Strategic Phase-out

Customer Info Package for:
OS-NFND-2026-001
Status: March 2026

Strategic Phase-out Customer Info Package

2. NFND: OSOLON™ Black Flat X

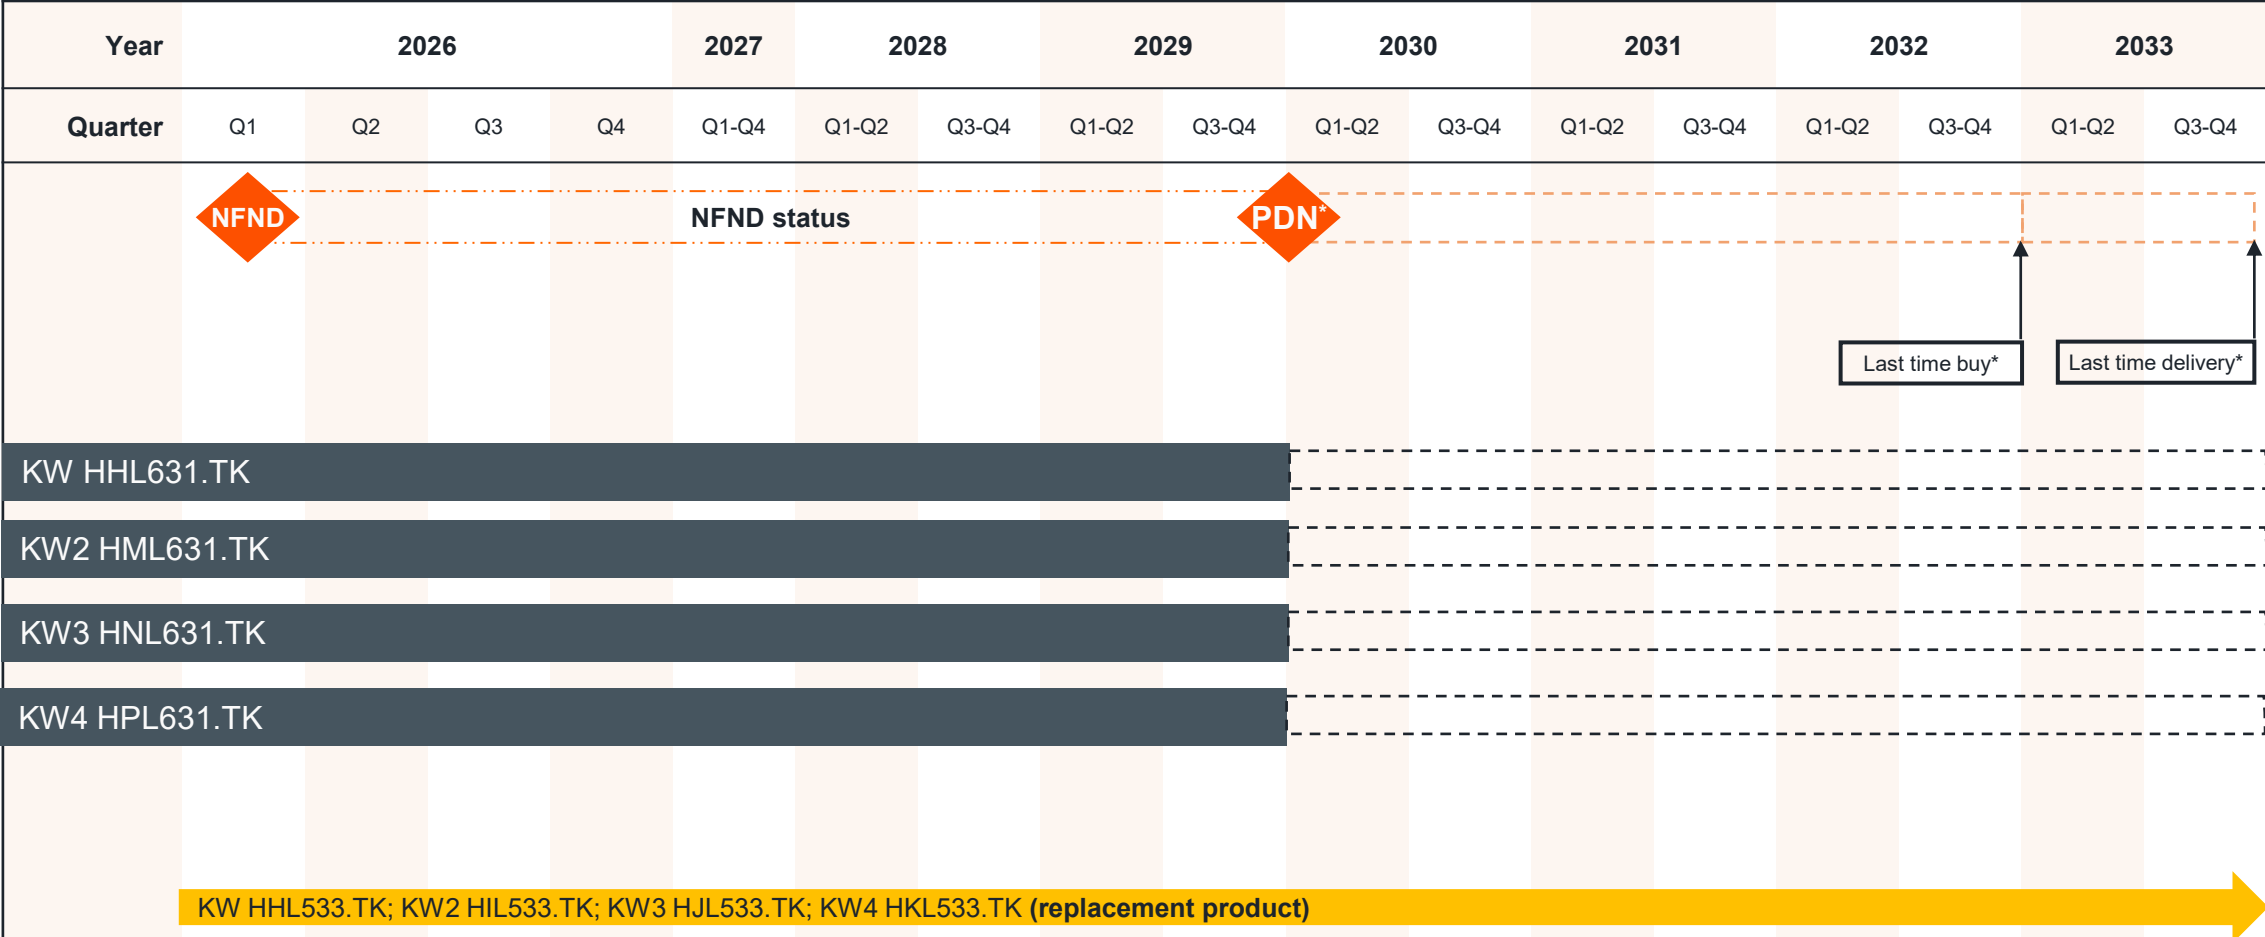
Target: streamlining of LED portfolio

Benefits: Successor device reaches similar performance at better price position

Note: No further price down for phase out devices

Product Family Name	Device	Status	PCN number & Publication Date	Replacement product available	NFND/PDN Number & issue date	LTB	LTD
OSOLON™ Black Flat X	 KW HHL631.TK	●	-	KW HHL533.TK	OS-NFND-2026-001 PDN: Q4/2029	Q4/2032	Q4/2033
	 KW2 HML631.TK	●	-	KW2 HIL533.TK	OS-NFND-2026-001 PDN: Q4/2029	Q4/2032	Q4/2033
	 KW3 HNL631.TK	●	-	KW3 HJL533.TK	OS-NFND-2026-001 PDN: Q4/2029	Q4/2032	Q4/2033
	 KW4 HPL631.TK	●	-	KW4 HKL533.TK	OS-NFND-2026-001 PDN: Q4/2029	Q4/2030	Q4/2031
	 KW5 HQL631.TK	●	●	-	KW HLL531.TE	OS-PDN-2026-011	Q1/2027

3. NFND: OSOLON™ Compact PL (1150µm)

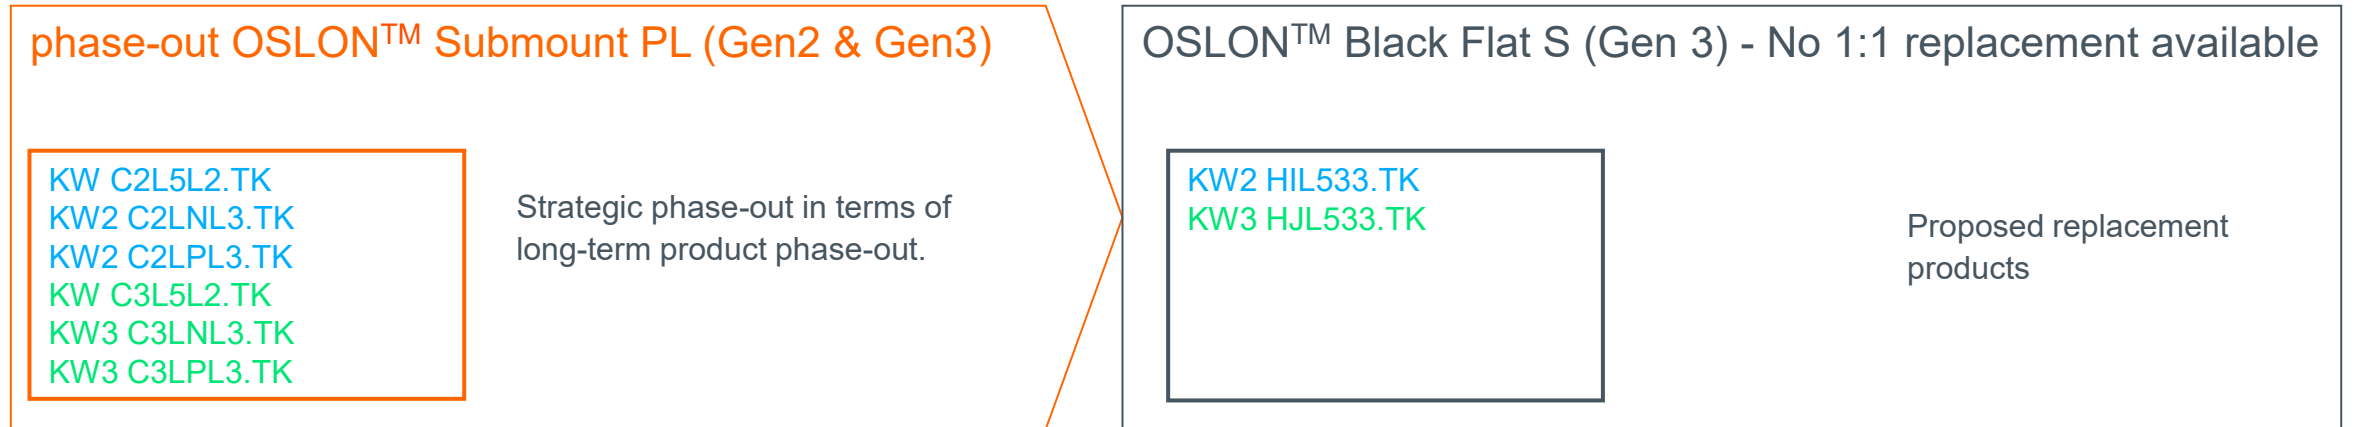
Target: streamlining of LED portfolio

Benefits: Successor device reaches similar performance at better price position

Note: No further price down for phase out devices
KW CELNM4.TK is covering both color regions (KW CWLPM3.TK & KW CWLPM3.T1)

Product Family Name	Device	Status	PCN number & Publication Date	Replacement product available	NFND/PDN Number & issue date	LTB	LTD
OSOLON™ Compact PL	 KW CWLPM3.TK			KW CELNM4.TK	OS-NFND-2026-001 PDN: Q4/2029	Q4/2032	Q4/2033
	 KW CWLPM3.T1			KW CELNM4.TK	OS-NFND-2026-001 PDN: Q4/2029	Q4/2032	Q4/2033
